CALIFORNIA REGIONAL WATER QUALITY CONTROL BOARD - SAN DIEGO REGION

FACILITY INSPECTION DATA ENTRY FORM

Roripaugh Ranch Tract 29353  
 FACILITY OR DEVELOPER NAME (if different from owner)

On November 15, 2006, Kristin Schwall and Jimmy Smith inspected the Roripaugh Ranch construction site. Construction WDID: 9 33C320657

Photo 5. Top of completed bridge at Loop Road over Long Valley Wash. Bridge is a low point for water to accumulate. Additional BMPs are needed to prevent concentrated flow along road from causing erosion.

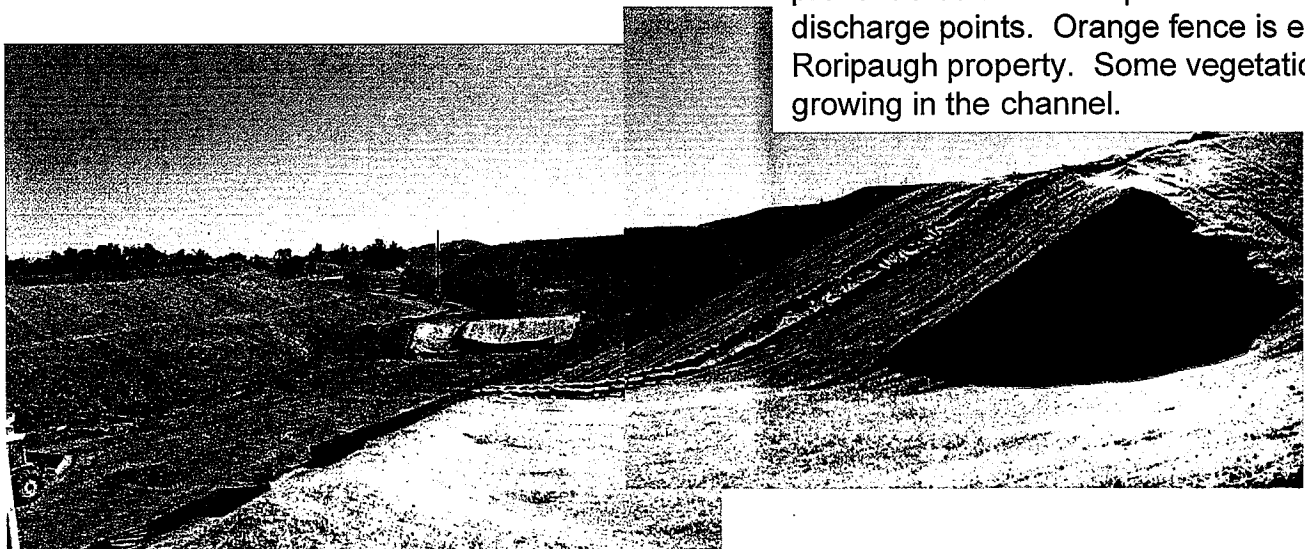
Photo 6. Loop Road bridge looking south. Additional BMPs are needed along road and at toe of slopes. Any unstabilized slopes should be stabilized.

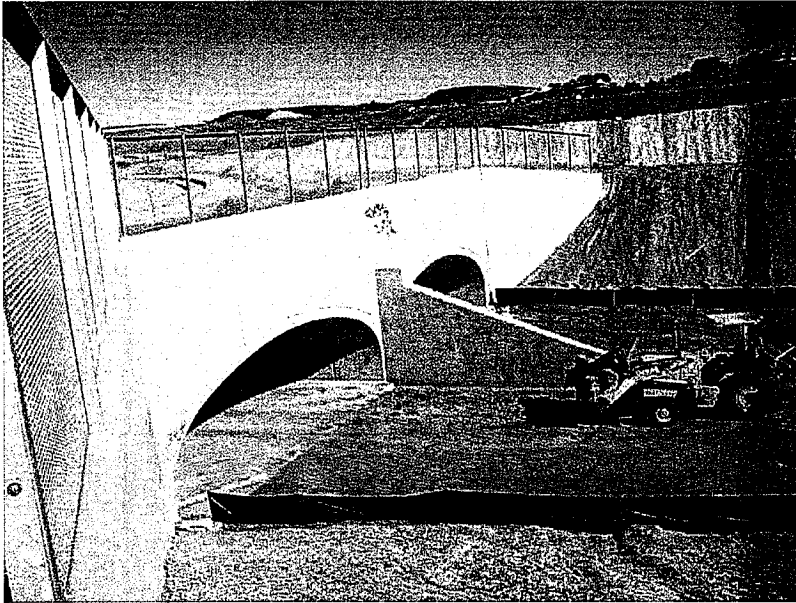
Photo 7 & 8. Loop Road bridge looking upstream. A dike has been constructed in the channel. The dike should be removed. Any concentrated flow spillways should be fully stabilized to prevent erosion at flow paths and discharge points. Orange fence is end of Roripaugh property. Some vegetation is growing in the channel.

Photo 15. Visqueen lined berm in Long Valley Channel downstream of Loop Road bridge should be removed. Long Valley Wash is to remain in its natural state and the creek should not be used as a BMP.

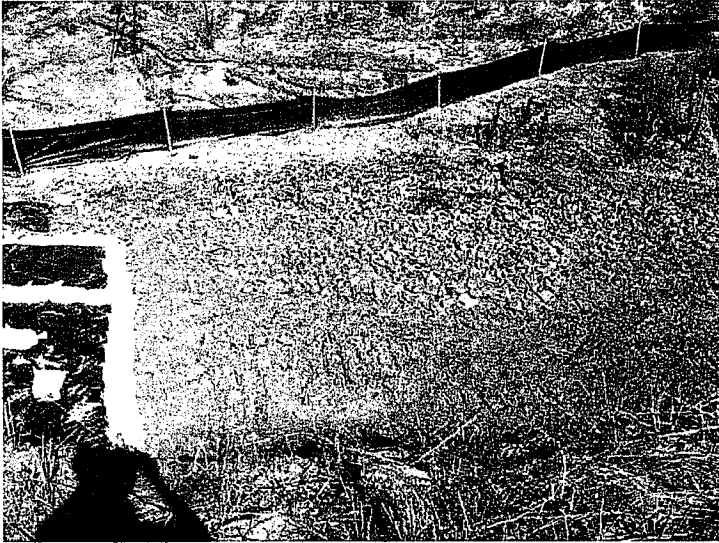
Photo 16. Long Valley Wash downstream of the berm in photo 15. Channel should be returned to its original state.

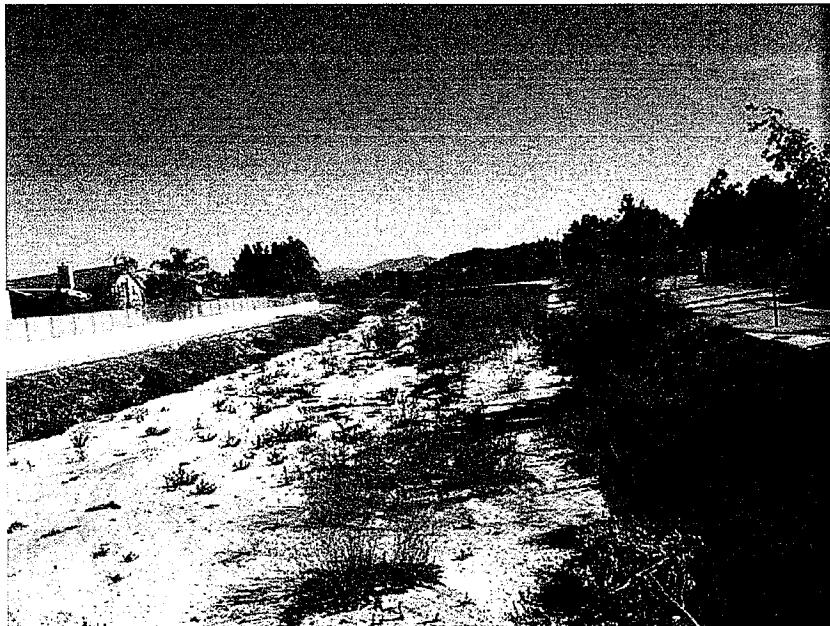
Photo 21. Santa Gertrudis Creek downstream of photo 19 and 20 facing downstream at General Kearny Road. This section of the creek had recently been mowed. The large amount of vegetation is likely due to a storm drain discharge. The trees on the right are in a park adjacent to the creek behind a chain link fence.
